CROSSROADS MIXED USE FILING NO. 1

CONSTRUCTION PLANS

DECEMBER 2021

EL PASO COUNTY FILE NO. SF 21-029

TRUCK APRON DETAIL (Z-Z)

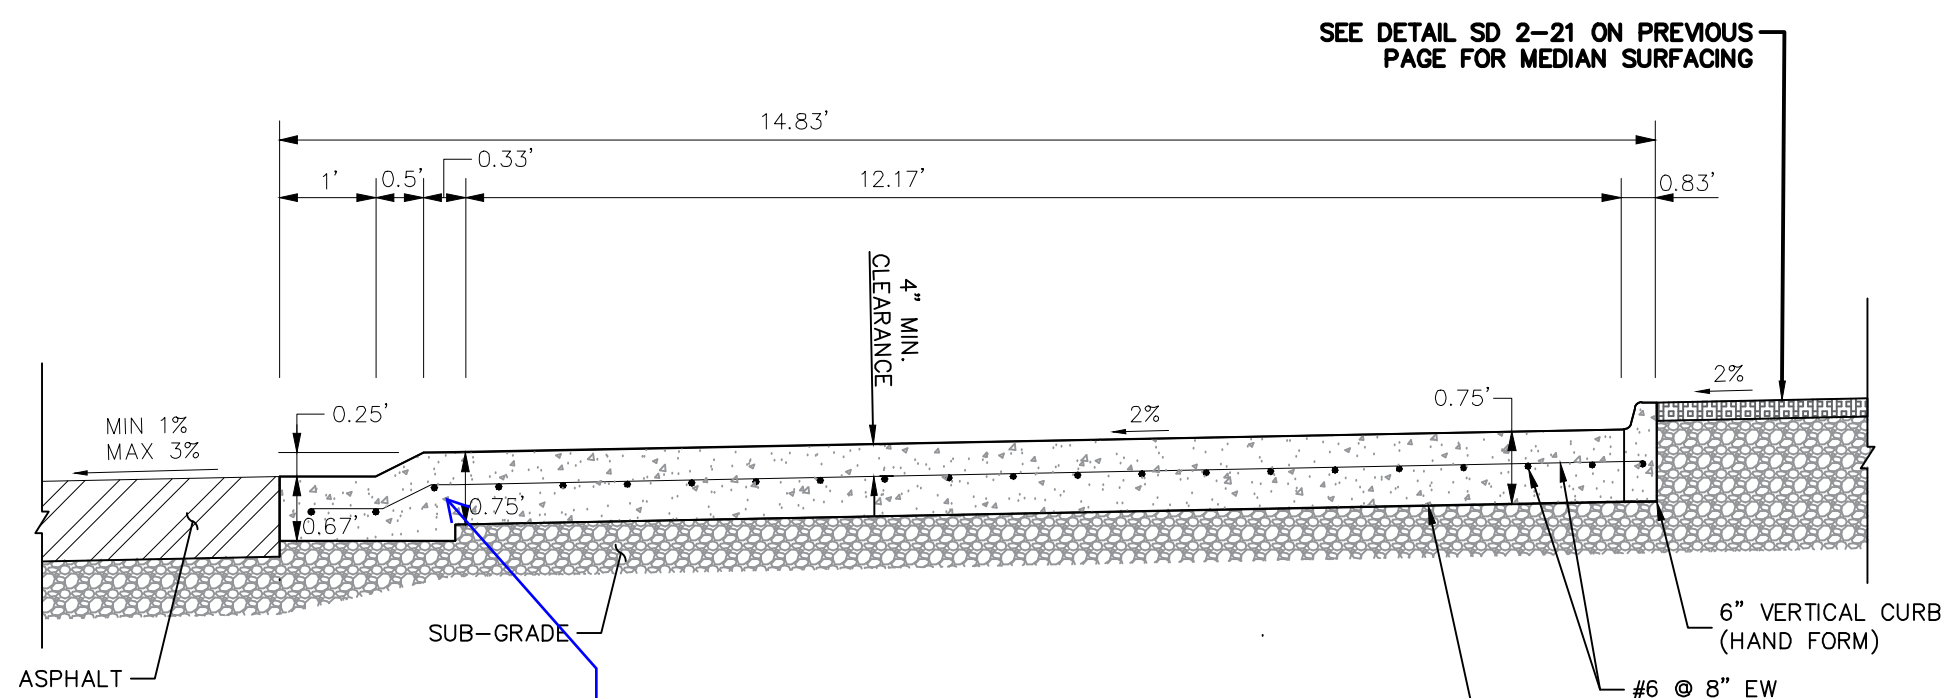
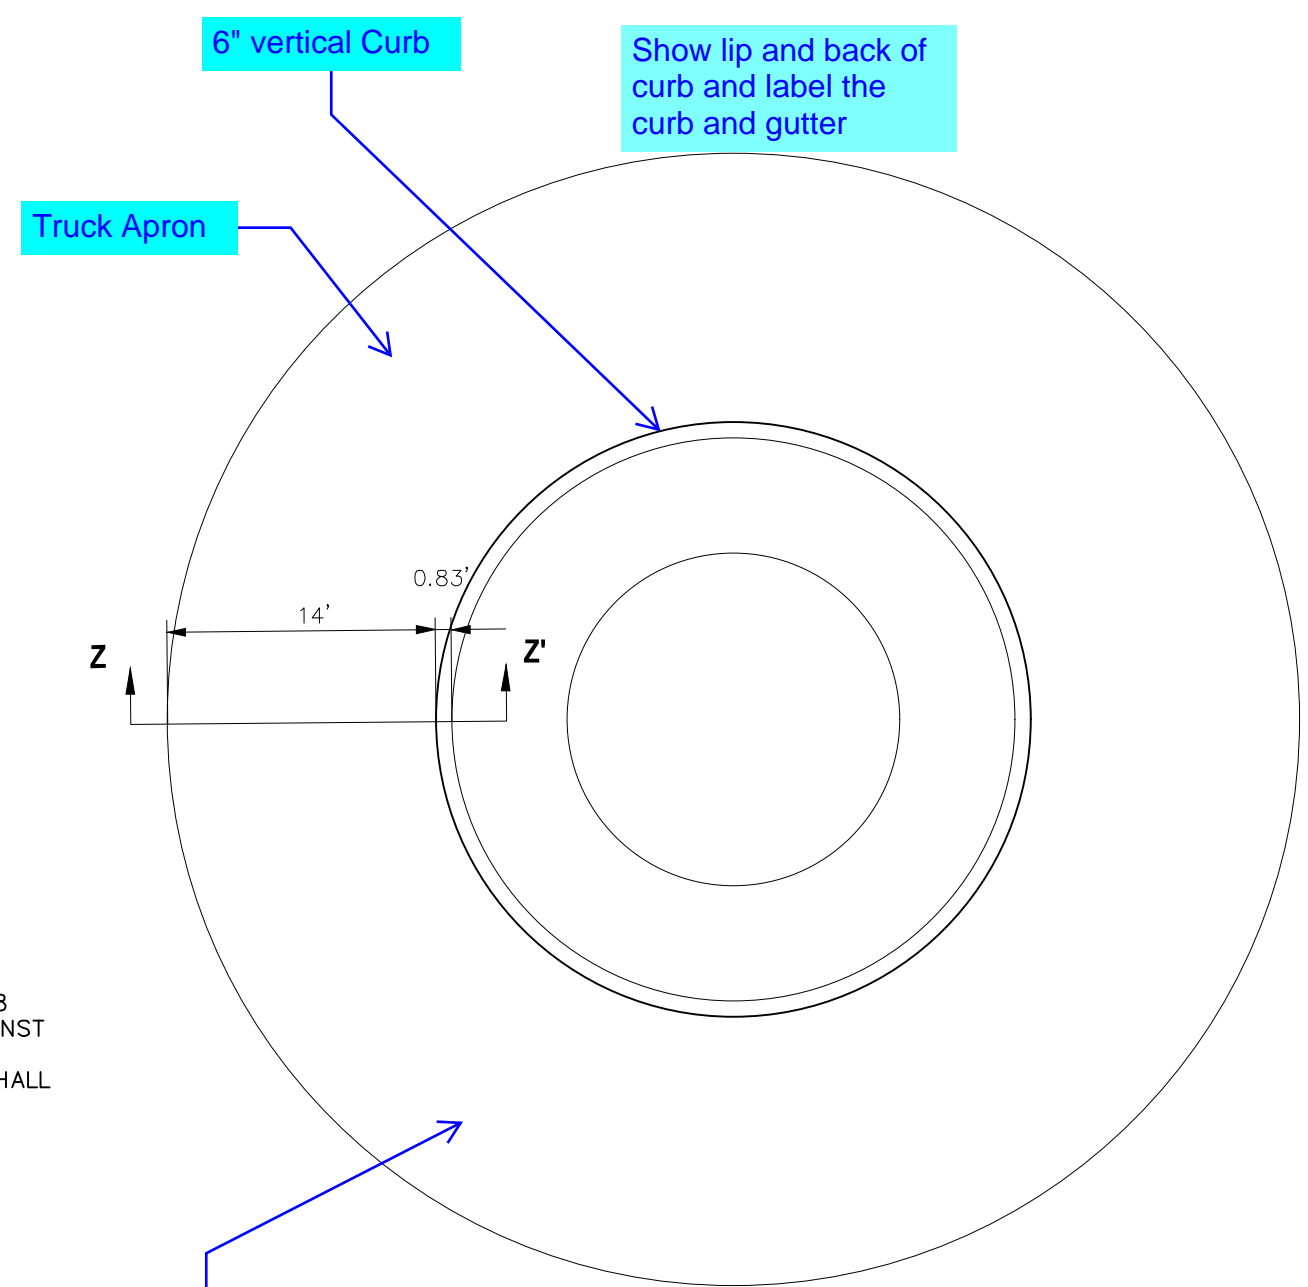
Revise. The curb and gutter and apron are separate elements, not monolithic pour

Hatch apron area with concrete and median surface area with hatches to match detail on left

SHEET 6 OF 23
S106

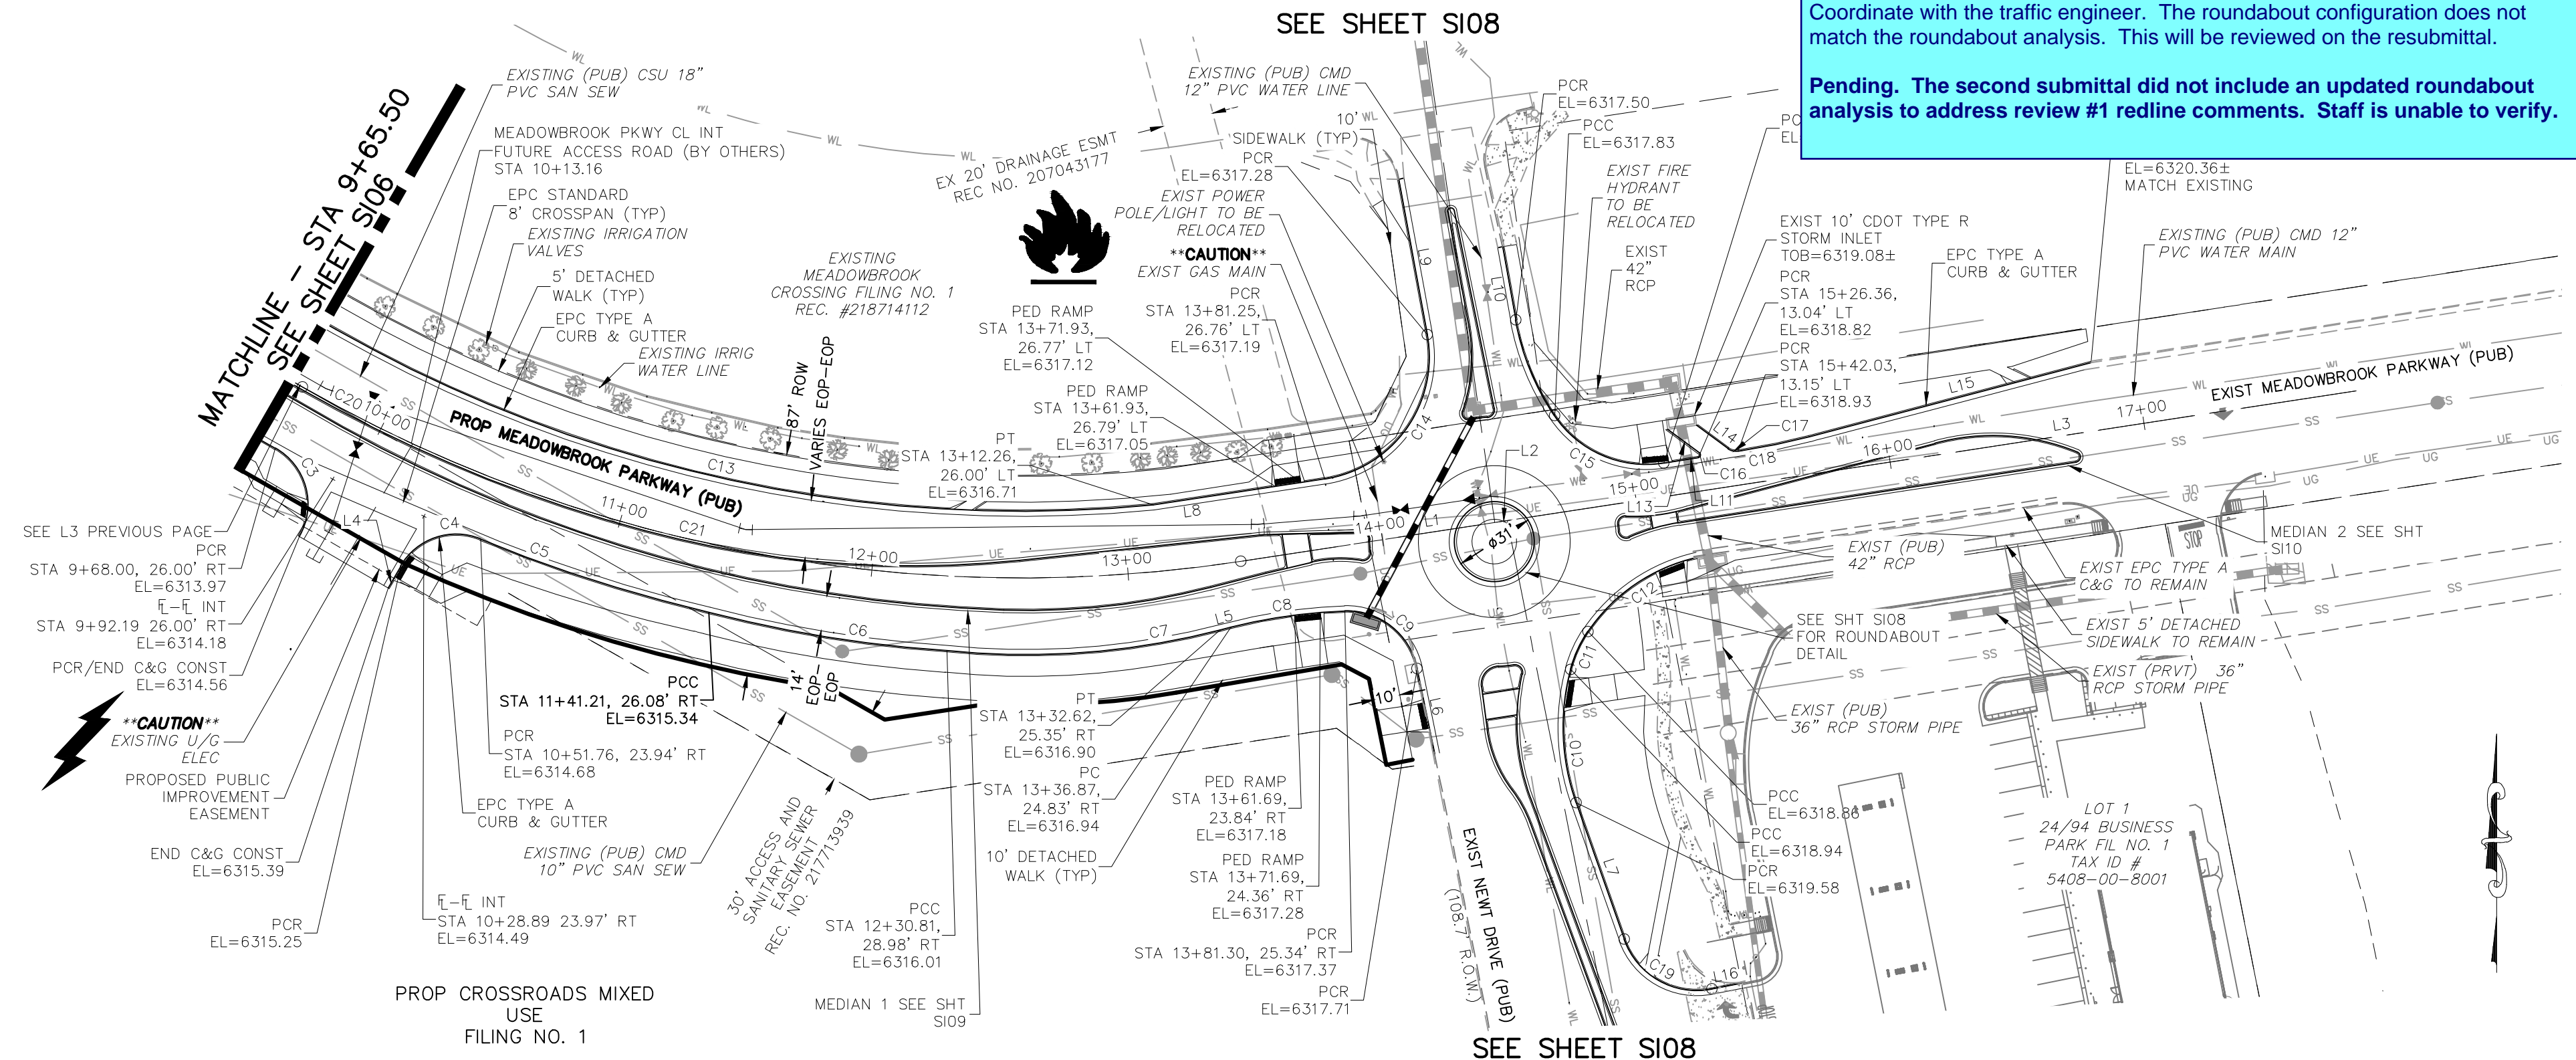
Coordinate with the traffic engineer. The roundabout configuration does not match the roundabout analysis. This will be reviewed on the resubmittal.
Pending. The second submittal did not include an updated roundabout analysis to address review #1 redline comments. Staff is unable to verify.

STREET IMPROVEMENT PLANS

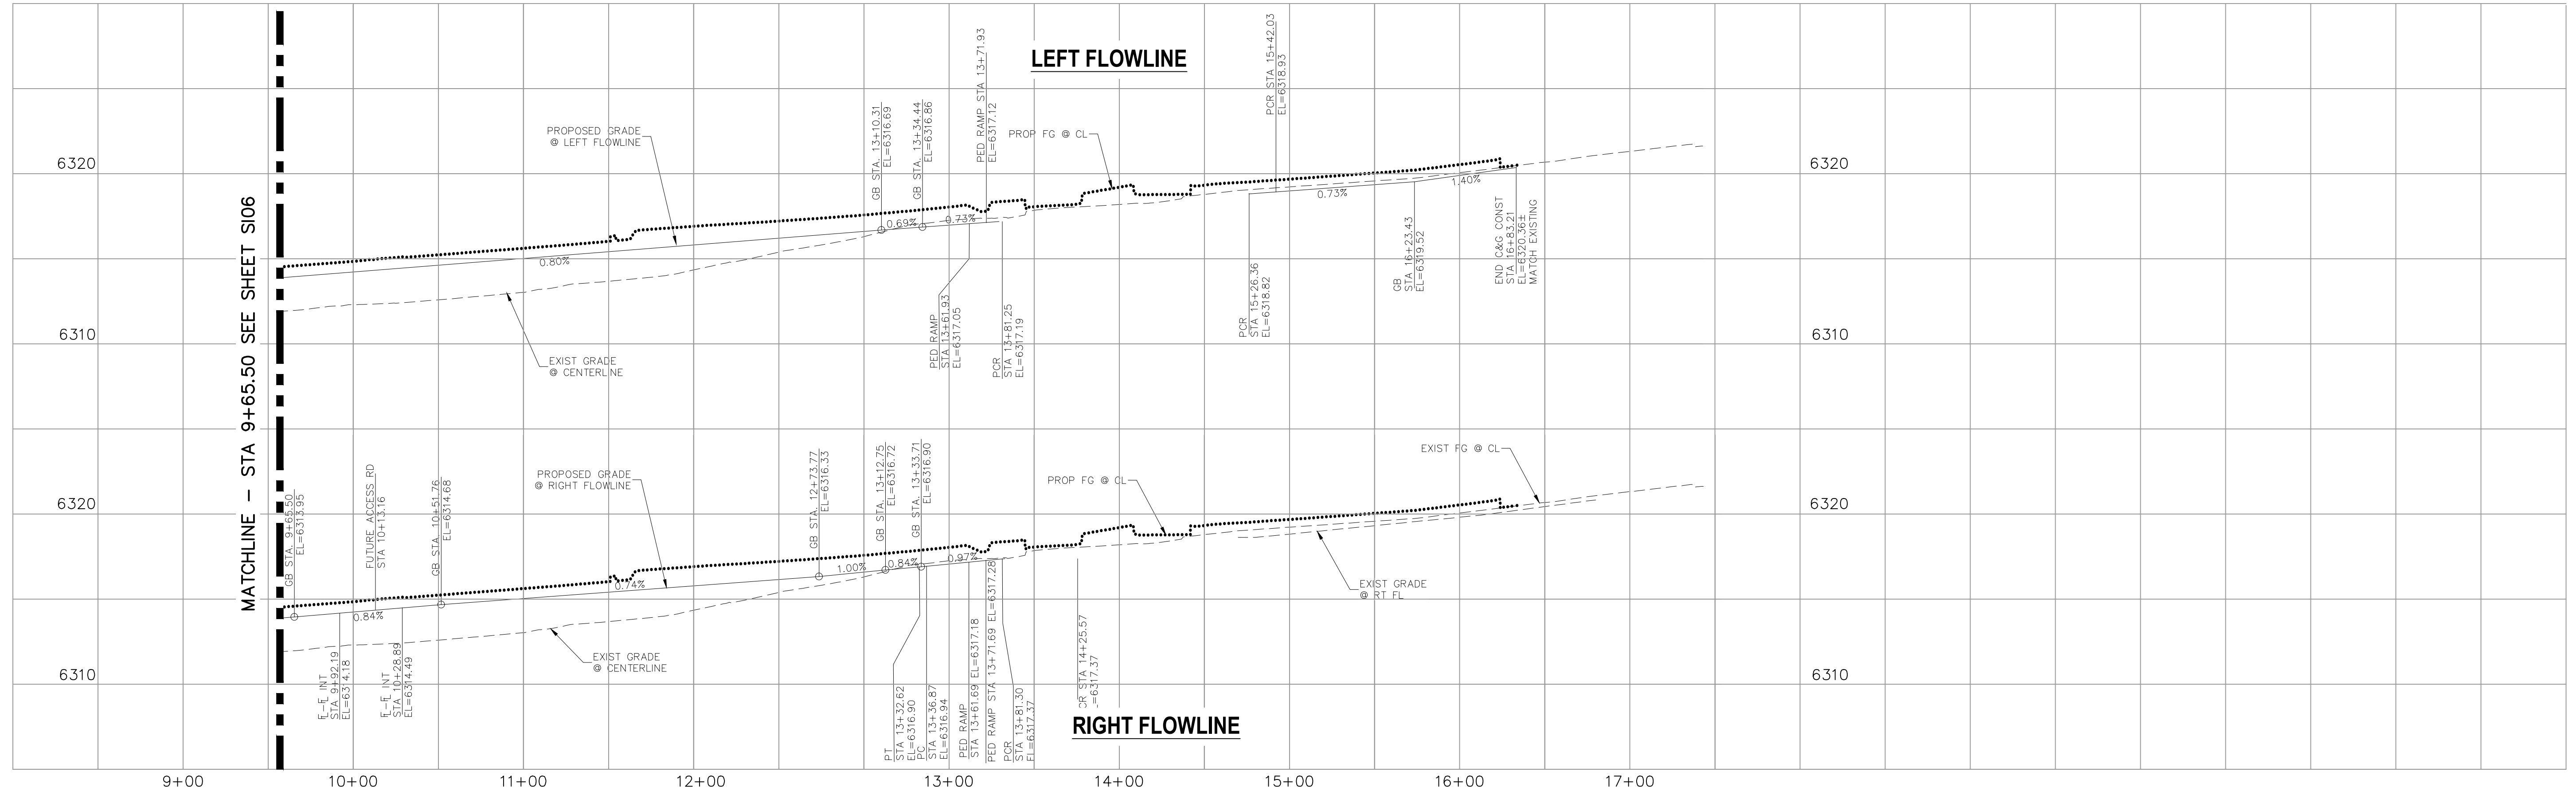
Coordinate with the traffic engineer. The roundabout configuration does not match the roundabout analysis. This will be reviewed on the resubmittal.
 Pending. The second submittal did not include an updated roundabout analysis to address review #1 redline comments. Staff is unable to verify.

Looks like there may still be conflict with manhole and c&g. Add note to field verify manhole in relation to c&g prior to installation of c&g and add reference to see Note 3.

Conflict with phone pedestal in roadway.
